# Groundwater Sampling Summary Report for Sites 13 and 22

Naval Weapons Station Seal Beach Detachment Concord  
Concord, California

**DRAFT FINAL**

**RESPONSE TO COMMENTS FROM EPA**

**FIGURE 1**  
**SITE 13 MONITORING WELL LOCATIONS**  
**AND PERCHLORATE CONCENTRATIONS**  
**IN GROUNDWATER**

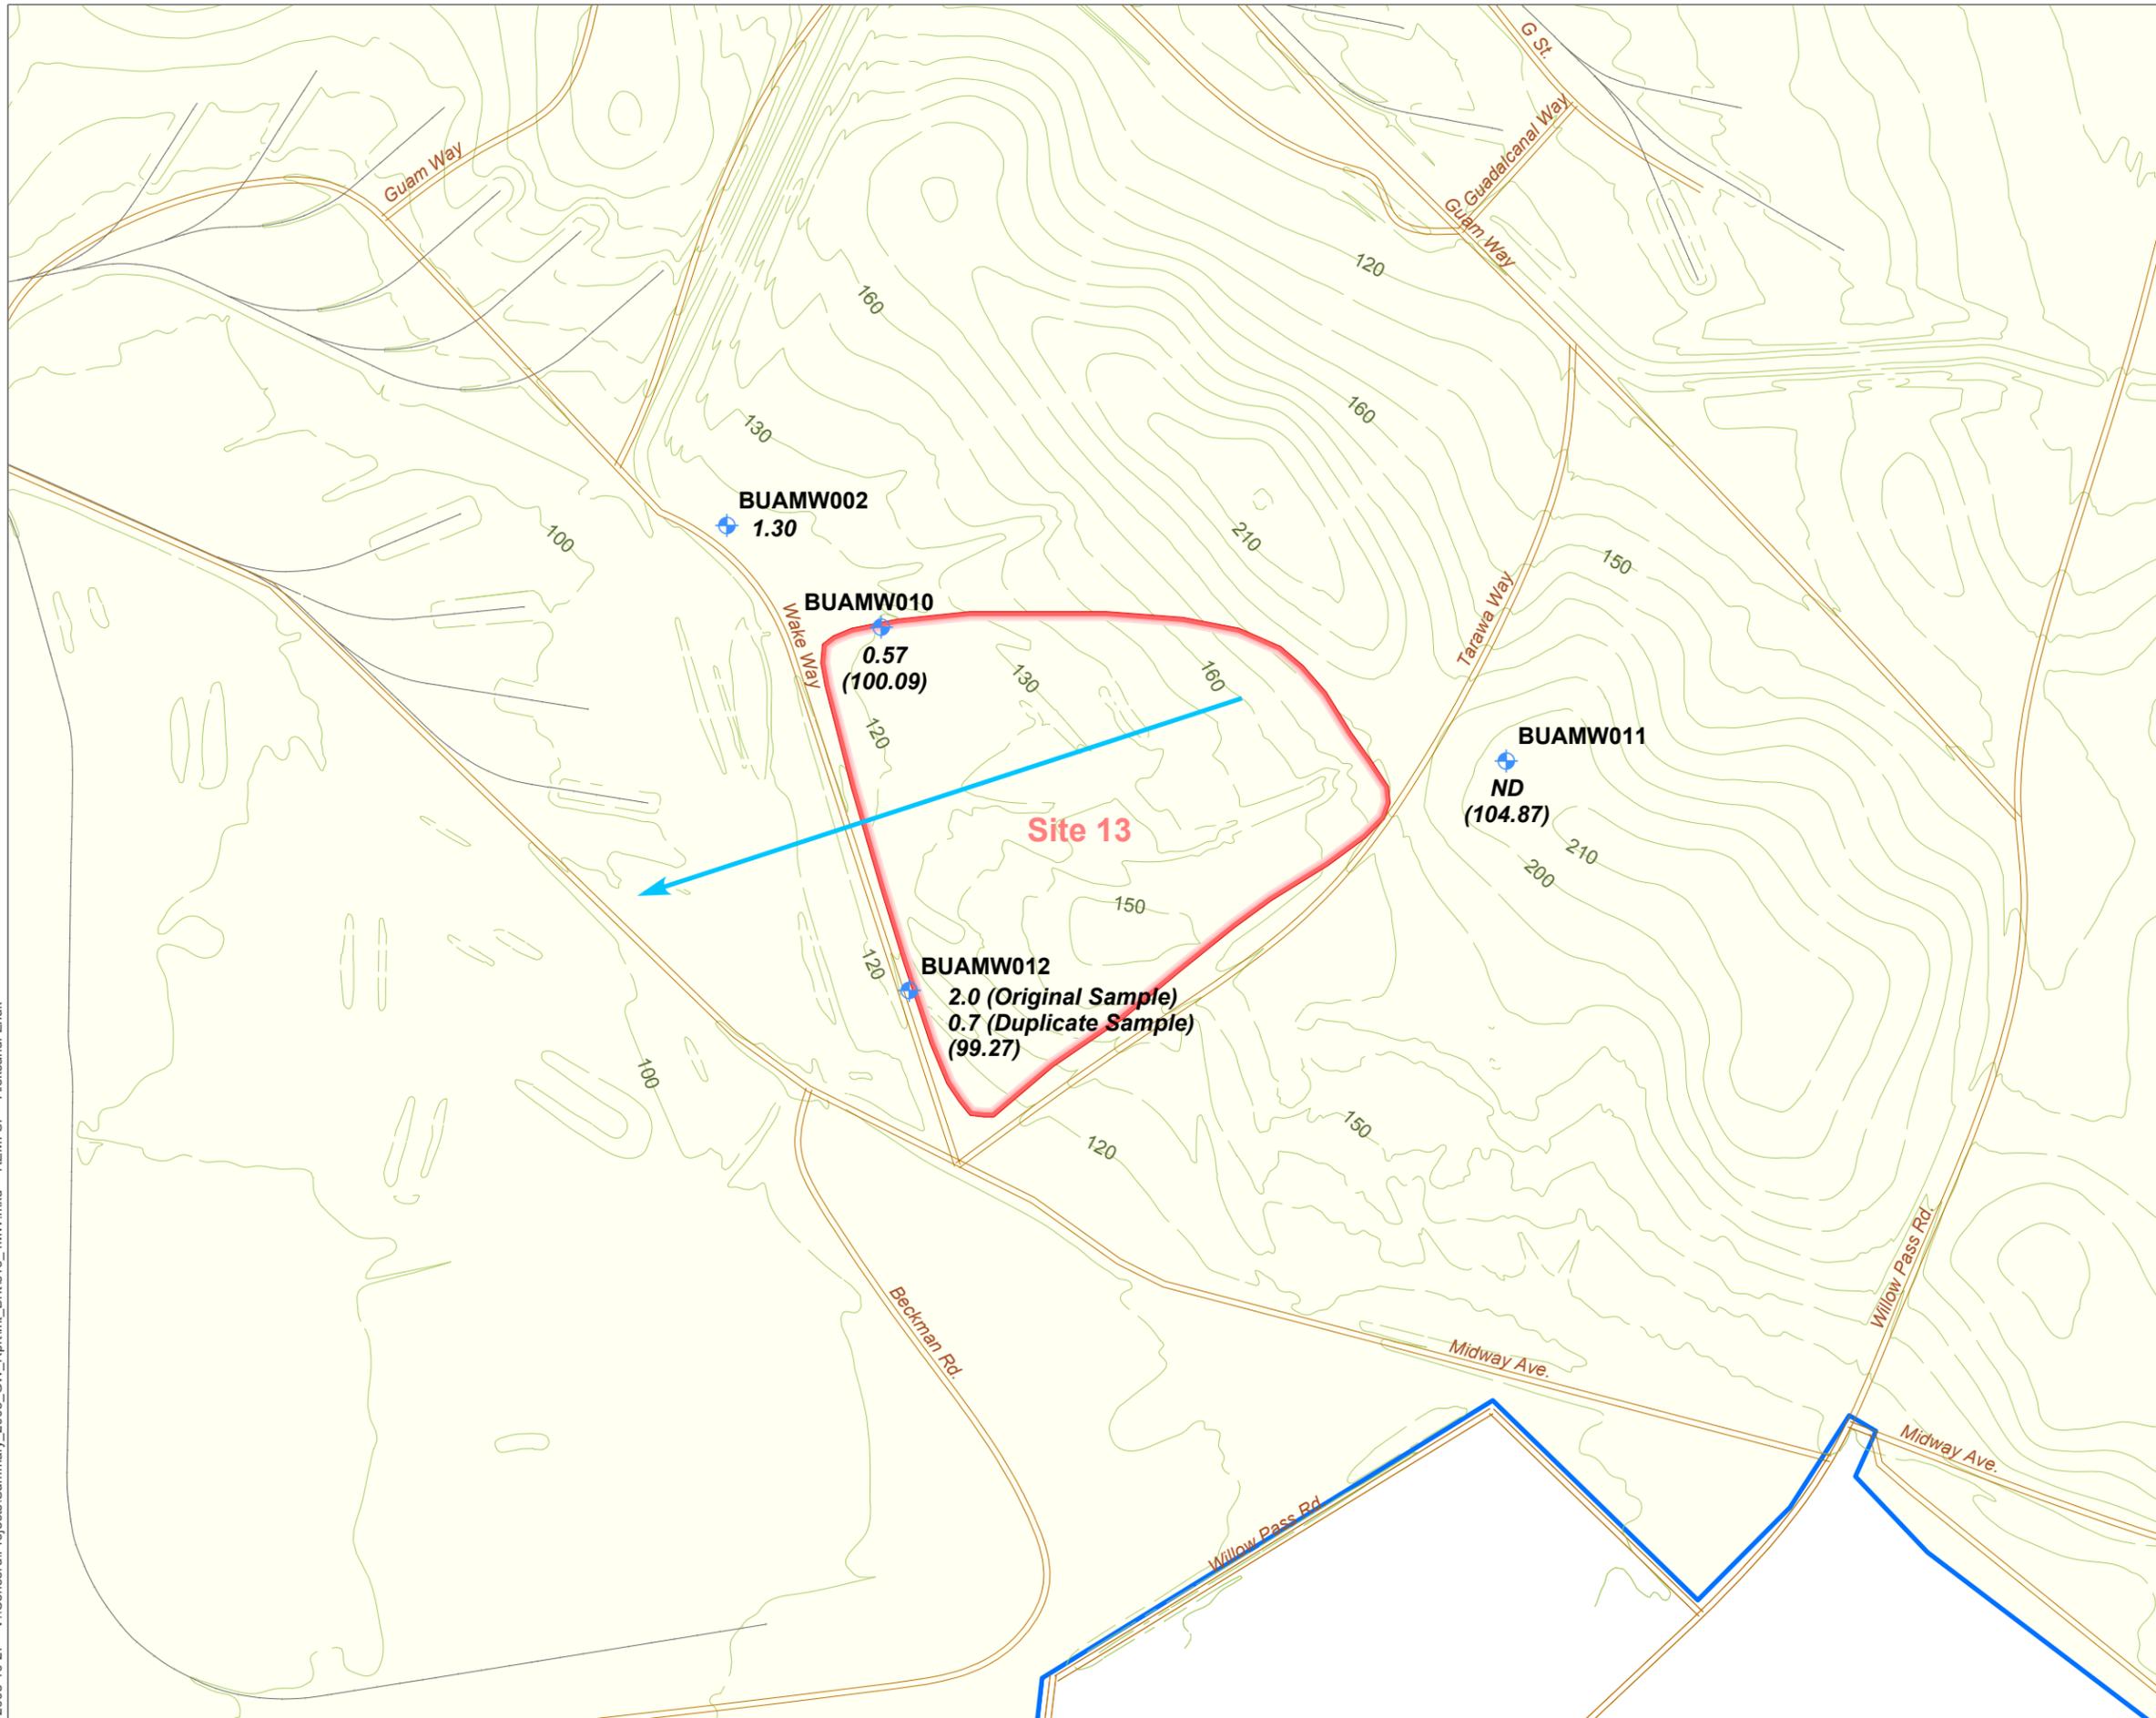
**Figure 1, Site 13 Monitoring Well Locations and Perchlorate Concentrations: Two existing piezometers at Site 13 should be considered for integration with any future Site 13 groundwater assessments. As discussed between the U.S. EPA and the Navy prior to developing the Sampling and Analysis Plan for the draft Groundwater Sampling Report, two existing piezometers at Site 13 should be evaluated for groundwater sampling. The Navy’s preliminary response was that these wells may not be acceptable for groundwater sampling (because screen intervals were unknown); however, they should be acceptable for water elevation measurements. For the December 1, 2003, Site 13 draft Sampling**

**and Analysis Plan, please evaluate the piezometers for integration into the monitoring well network.**

5. SFBRWQCB Comment: **Figure 1 Site 13 Monitoring Well Locations and Perchlorate Concentrations in Groundwater: Clarify the statement: “Original/Duplicate Sample.”**

1. SFBRWQCB Comment: **Figures 1 and 2 Sites 13/ 22 Monitoring Wells Locations: Map the site’s topography, groundwater elevations, areas of documented perched groundwater on these figures.**

**Response:** Integration of the piezometers into the monitoring well network will be evaluated during the preparation of the Site 13 Draft Sampling and Analysis Plan (SAP).

**Response:** Two samples from the same well were collected as part of the quality assurance control program. The first sample collected is labeled the original sample, and the second sample collected is labeled the duplicate sample.

**Response:** The site topography and groundwater elevations have been added to [Figures 1](#) and [2](#). None of the wells sampled as part of this investigation are screened within perched groundwater areas. Thus, no areas of perched groundwater are shown on the figures.

NWS CONCORD - INLAND AREA CONCORD, CALIFORNIA			
<b>FIGURE 5-3</b> <b>SITE 13</b> <b>HYDROGEOLOGIC CROSS SECTION C-C'</b>			
SIZE	DATE	DWG NAME	REV
	06/05/96		1

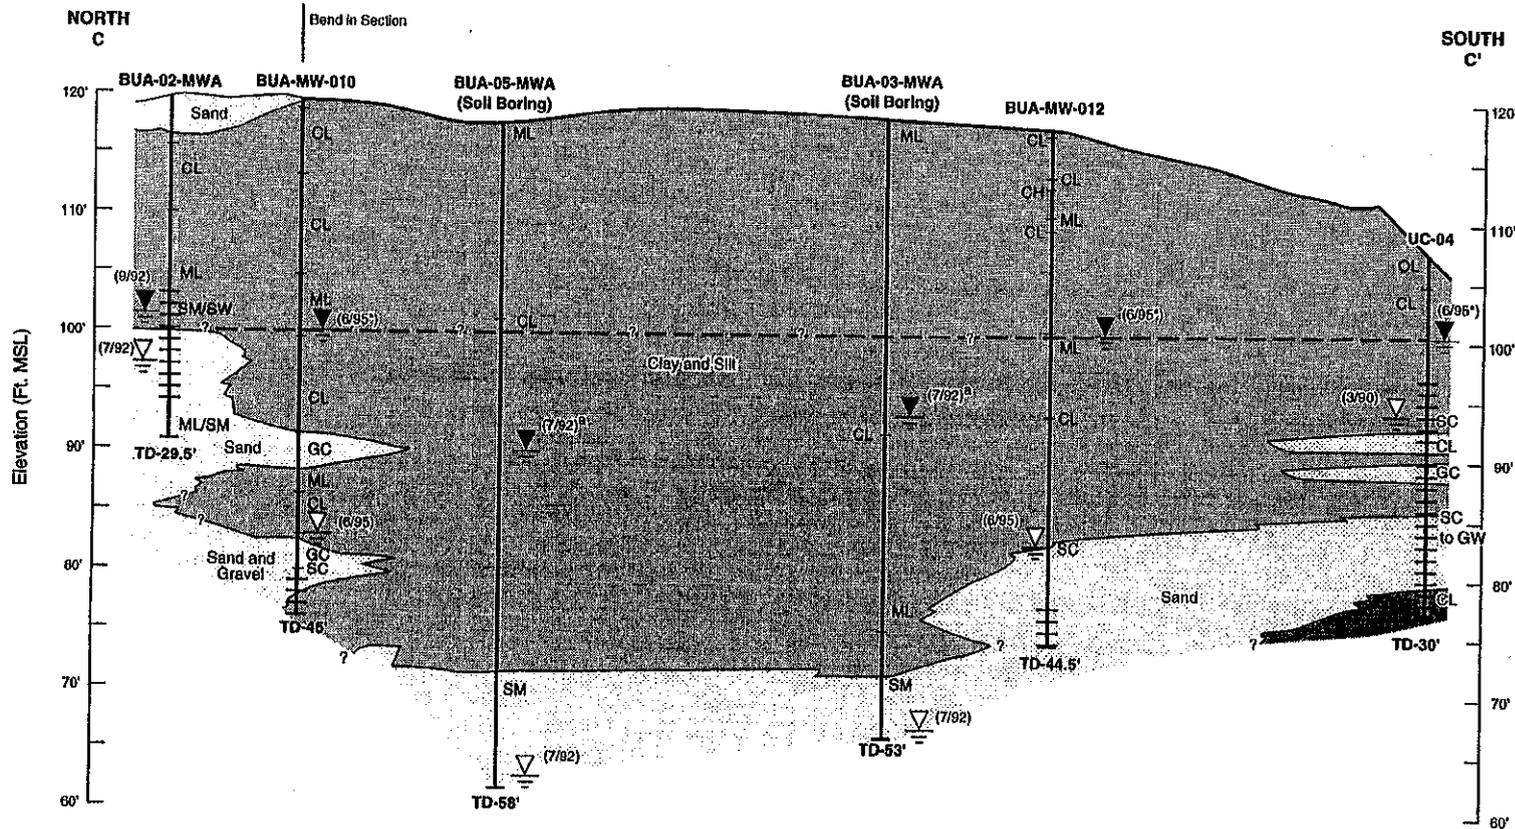
**1. SFBRWQCB Comment:** **The site’s 13 piezometers should be assessed to determine if hydrological sampling can be conducted at these locations. These piezometers should be mapped and their characteristics (such as depth, outer/inner diameters, water level) reported. The Navy’s preliminary response that they do not have information on the construction of these sampling points does not preclude their use as sampling points. Monitoring well BUAMW002 was sampled despite the absence of boring and construction logs.**

**Response:** As discussed above in the response to EPA comment 4, integration of the monitoring wells into the monitoring well network will be evaluated during preparation of the Site 13 Draft SAP. Although the well construction and borings logs are not available for Well BUAMW002, there is information regarding the surrounding lithology and construction of the well on the hydrogeologic cross section (Figure 5-3 in [Appendix B](#)).
